Chilmark Planning;  
Menemsha Corridor Plan for Improvement

Prepared for the:  
Martha's Vineyard Commission and the Town of Chilmark, MA

**October 30, 2017**

**Chilmark Planning;**  
**Menemsha Corridor Plan for Improvement**  
**North Road (Along Greenebaum property) - Concepts**  
**15 November 2017**

Above: Updated North Road parking along Greenebaum property.

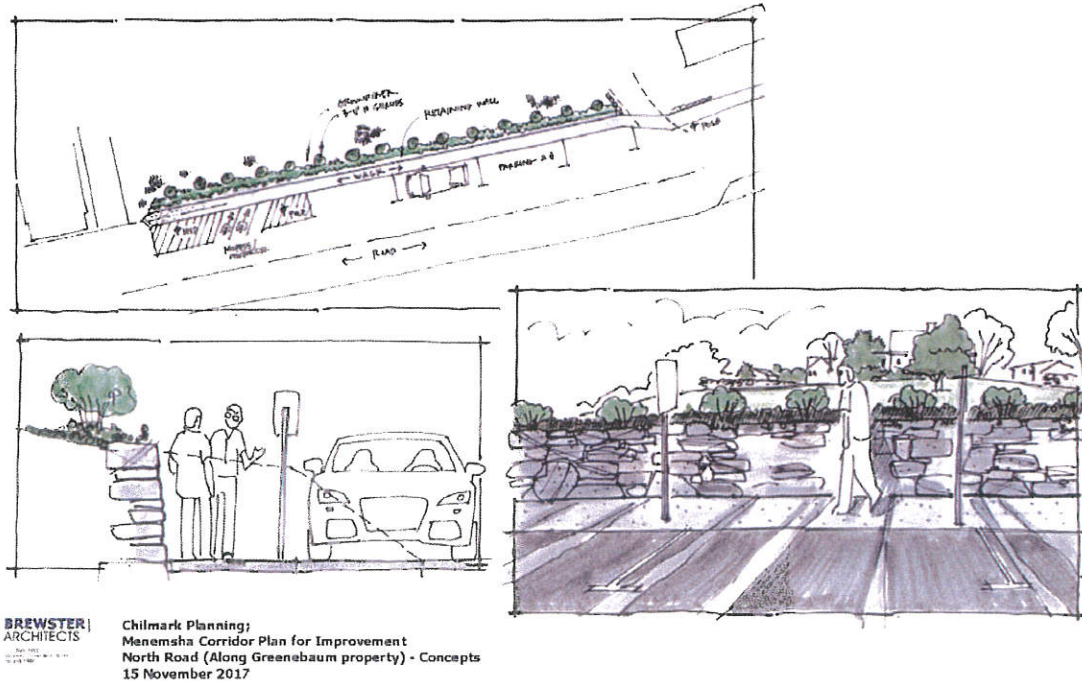
- B.0 Develop drawings showing an overview, an elevation and a section of the North Road/Greenebaum lot area developed for an additional walkway.  
*Response: Additional views of the Greenebaum property have been provided.*

Above: Updated Basin Road (North Road to Dutcher Dock) Concepts drawing showing additional cross-walks at 'The Bite.'

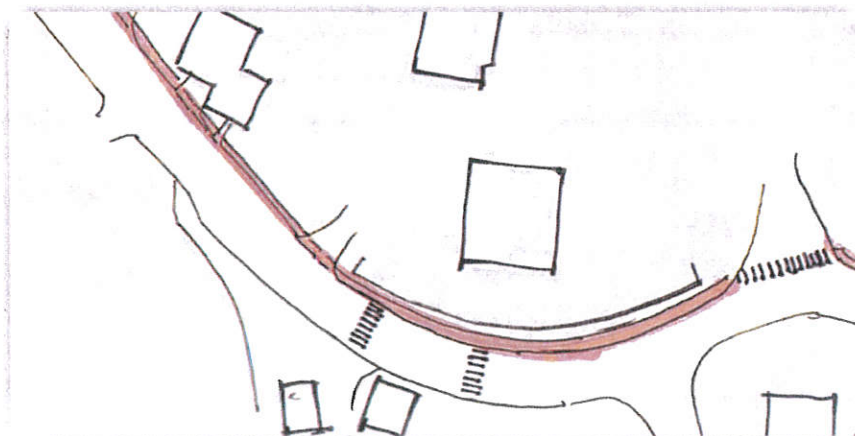
- B1.0 Provide on page 10, more clarification on exactly what is recommended for the Basin Road walkway/path.

*Response: This is shown as much as possible on the 'Overall Key plan – Concepts' as well as the enlarged plan views. Further definition of exactly where there is shell/gravel vs. existing pavement will require a much larger scale engineering drawing/survey to identify and finalize.*

Above: Cross-section through typical shell/gravel walkway

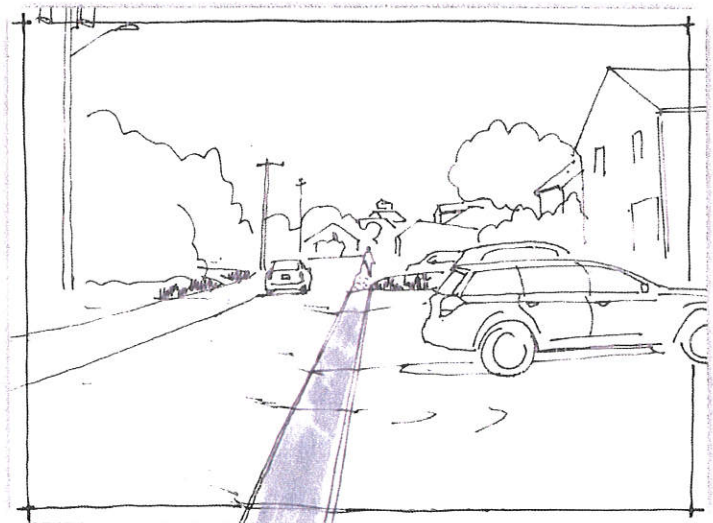
B1.1 Illustrate exactly where the shell/rock path is and where the painted areas and crosswalks are located and can you provide a very clear recommendation for the entire walkway/path in this area so that the person implementing the plan is clear on what is to be done.

B1.2 Add an additional sketch that fleshes out the Basin Road walkway so that more details could be seen.

*Response: Further definition of exactly where there is shell/gravel vs. existing pavement will require a much larger scale engineering drawing/survey to identify in the next phase.*

*Generically, wherever there is existing bituminous pavement adjacent to the roadway (i.e., parking for retail and restaurants, etc.), a simple painted path matching the shell/gravel path is proposed over the existing pavement. Discussions indicate that the painted path should be demarcated in solid gray pavement paint with a white painted edge line.*

Above: Looking west toward The Galley.

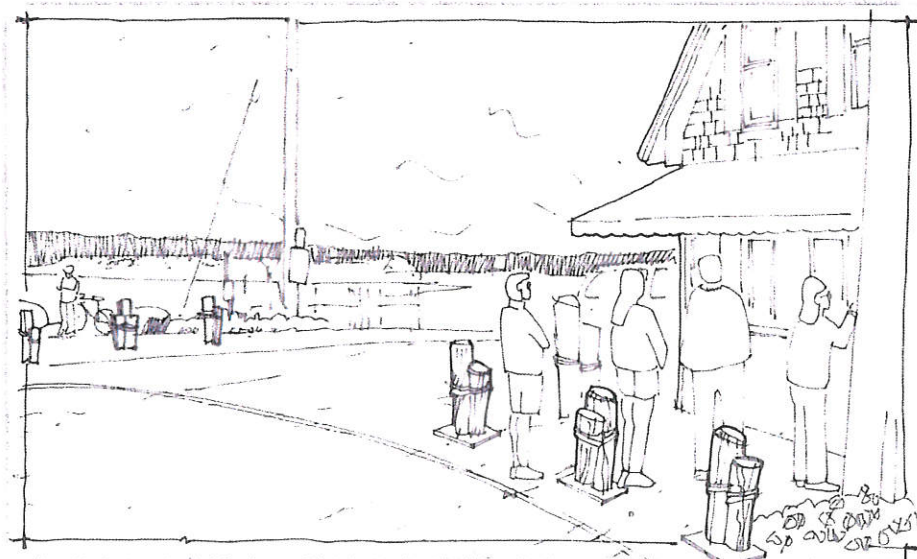
- a. Provide an additional sketch description and of the waiting area in front of the Galley.

Above: Updated vehicle and moped parking near Greenebaum parcel and bicycle racks at the Galley cul-de-sac.

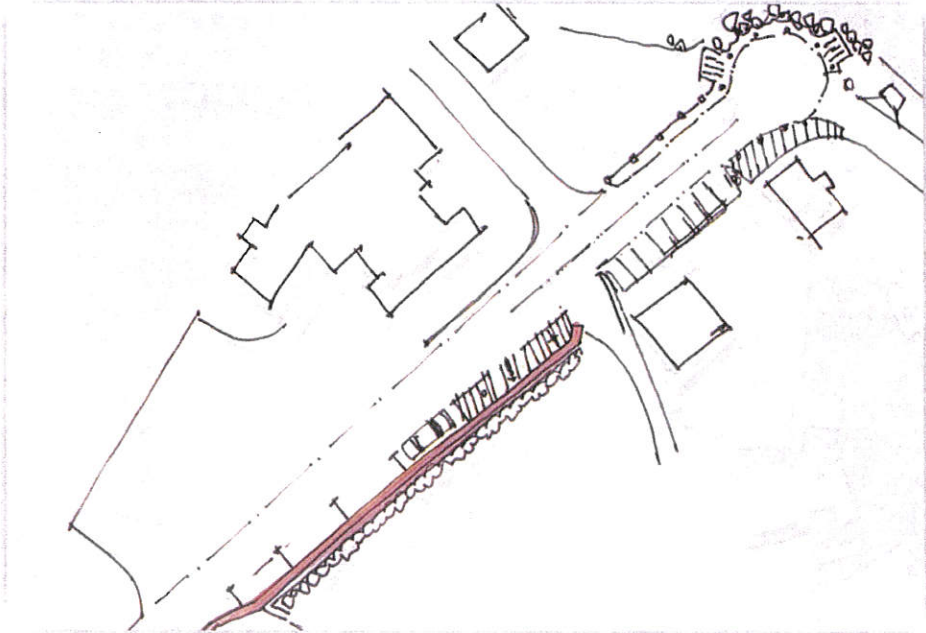
- b. Recommendations #4 & #5 do not appear to be shown on the accompanying sketch.  
*Response: Refer to Greenebaum parcel update, above.*

Above: Alternative Bus Turn-around beyond the Comfort Station, with Bus Shelter on north side.

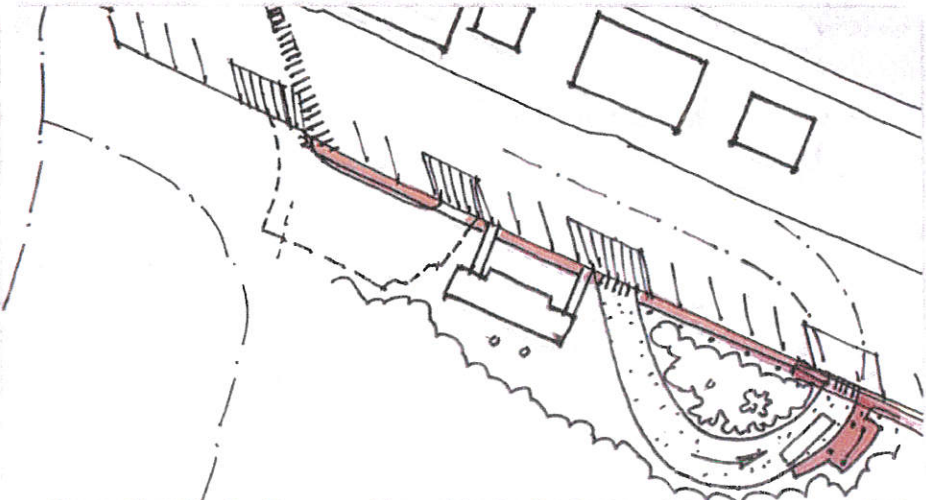
- B3.1 Provide sketch at turnaround after the comfort station, on pages 13-15, that the first south side "shell lot" remains and an additional "shell lot" is to be added on the north side of the Comfort Station with a passenger drop-off and embarkation site on that north side.

Above: Alternative beach access on north side of headwall and break-water.

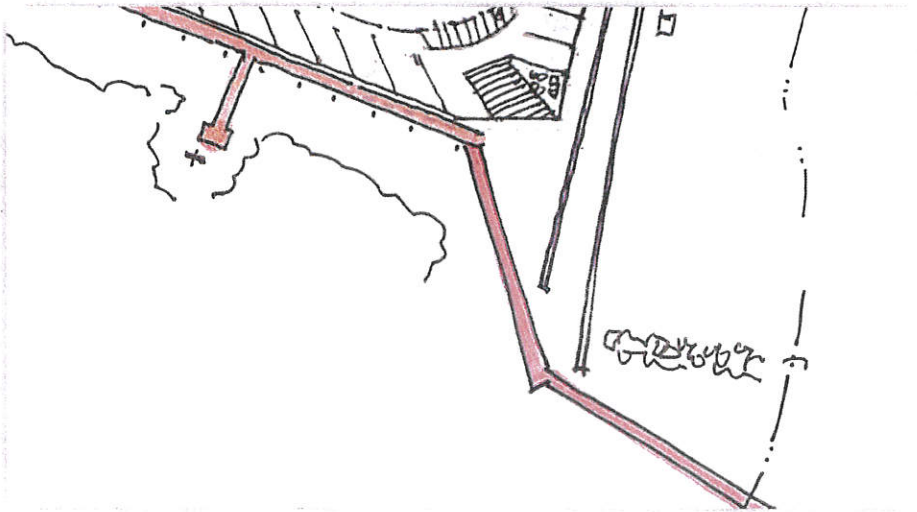
- B4.1 Provide an illustration of how a person using a wheelchair or walker or other type of access vehicles would access the beach from the parking lot.  
*Response: Drawing (p. 8) Dutcher Dock to Menemsha Beach Parking shows the proposed beach access through the new and existing headwall for a fairly direct route to the waterline. Alternatively, the path can be flipped such that the bulkhead can remain as it presently is, and the path configured to the north of the breakwater to the highwater line.*
